**Engineering Statement  
Prepared for Dane County  
Re:  
Proposed WBKY Tower Site #2157  
Township of Rutland

Application for CUP**

**January 25, 2011**

**Re:  
Proposed WBKY Tower Site #2157  
3768 Old Stage Road  
Township of Rutland**

**Figure 1 – Site Location Area**

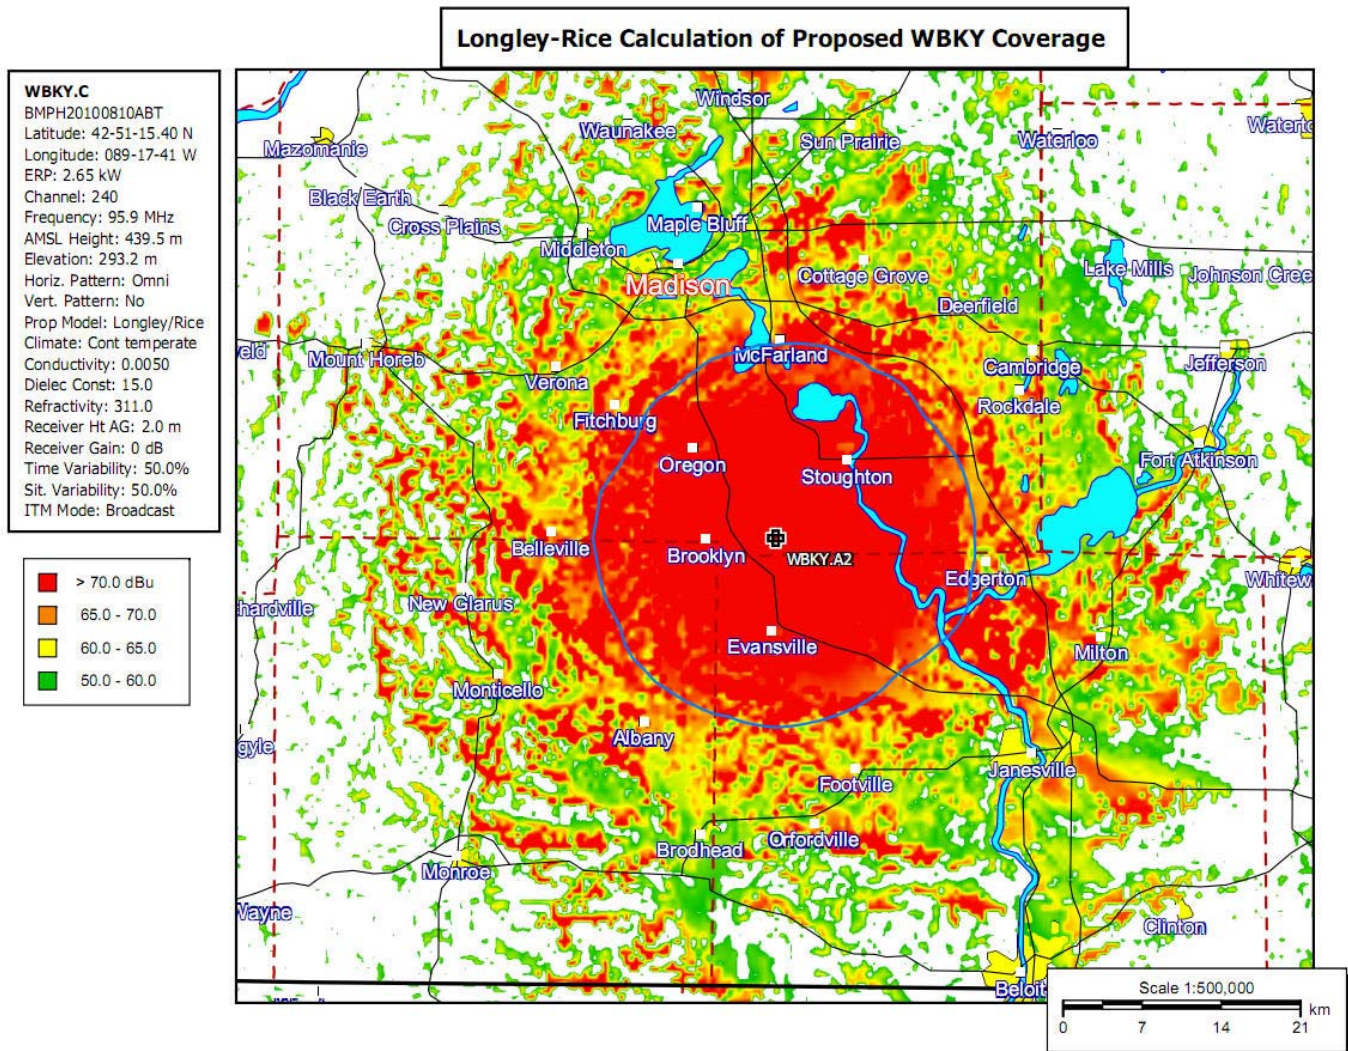
Figure 1, attached, shows the area within which the tower may be located according to the FCC's allocation and city coverage rules. There are no known FCC registered towers within this area, the closest being only 200' high and outside of the siting window. It should be noted that cell towers under 200 feet do not require FCC registration.

Evans has rechecked the Magnum search area map, and the result is shown in Figure 1. The proposed site is located at the northwestern boundary of the area (see Section #9 of this report). It is the intent of the County's Ordinance to populate the county with the minimum number of structures by requiring co-location. Since there are several Internet, cell and PCS providers in the Dane County area, additional providers could be expected to co-locate at this proposed site, especially as wireless Internet services become more prevalent. The tower will be placed near a gravel pit, and partially shielded by trees. In this engineer's opinion, it probably would be difficult to replicate this confluence of factors within the remainder of the siting area.

**Figure 2 – Propagation Map Using Proposed Facilities**

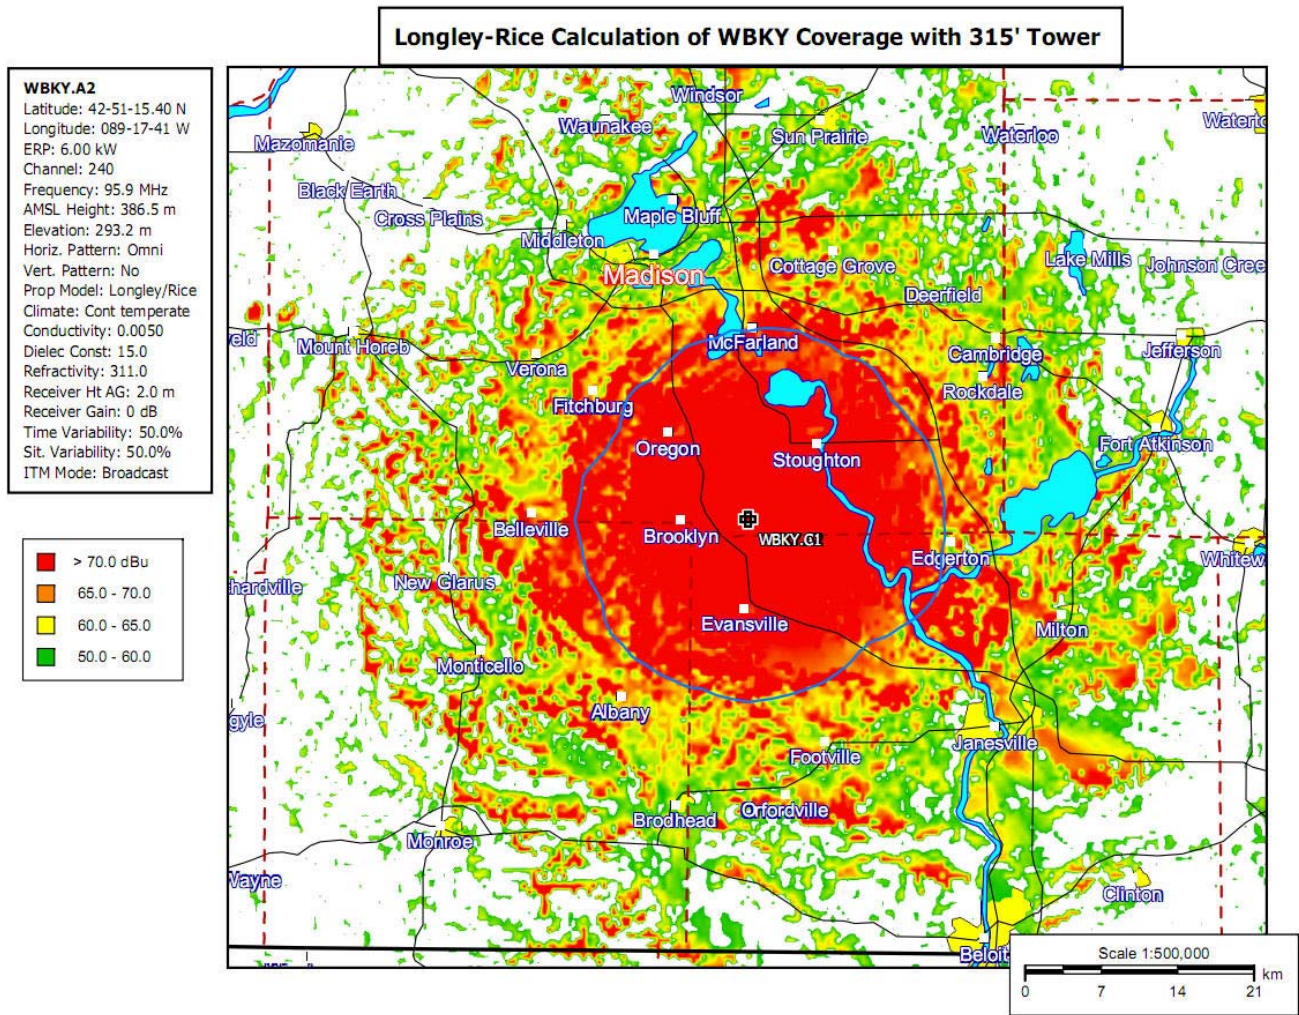
The attached figures 2, 3 and 4 show the level of reception to be expected at 488, 315, and 400 feet above ground level. The color scheme used for the attached propagation maps is as follows:

The best service among these three exhibits is rendered at 488 feet.

**Figure 3 - Propagation Map at 315'**

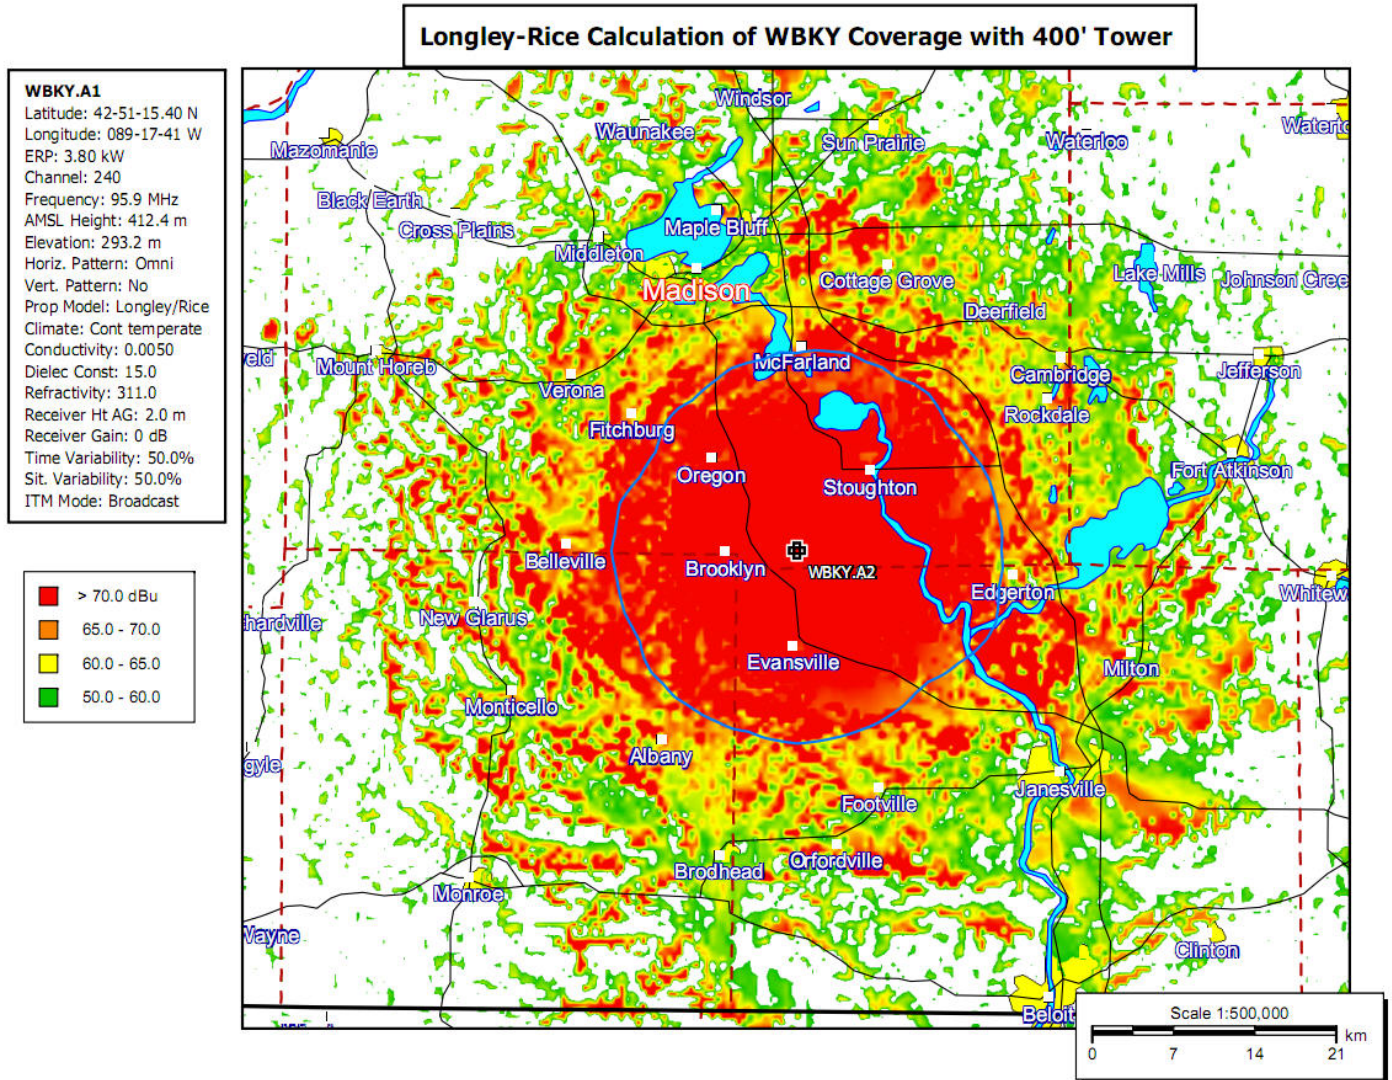
To evaluate the effect of shorter towers than that proposed, Evans ran propagation analyses at 315' and 400' in addition to the proposed height of 488 feet. In Magnum's opinion, the maximum height represents the minimum that will achieve the required technical objectives. The attached propagation maps show the effect of decreasing tower height, and paragraph III-5 shows the relative population associated with each. While the 315'<sup>4</sup>, 400' and 488' maps show definite differences in coverage, it certainly may be argued that the difference in performance between a tower of an intermediate height, say 450', would be minor compared to that at 488'. However, the differential visual impact would be minor as well, thereby achieving a dubious benefit.
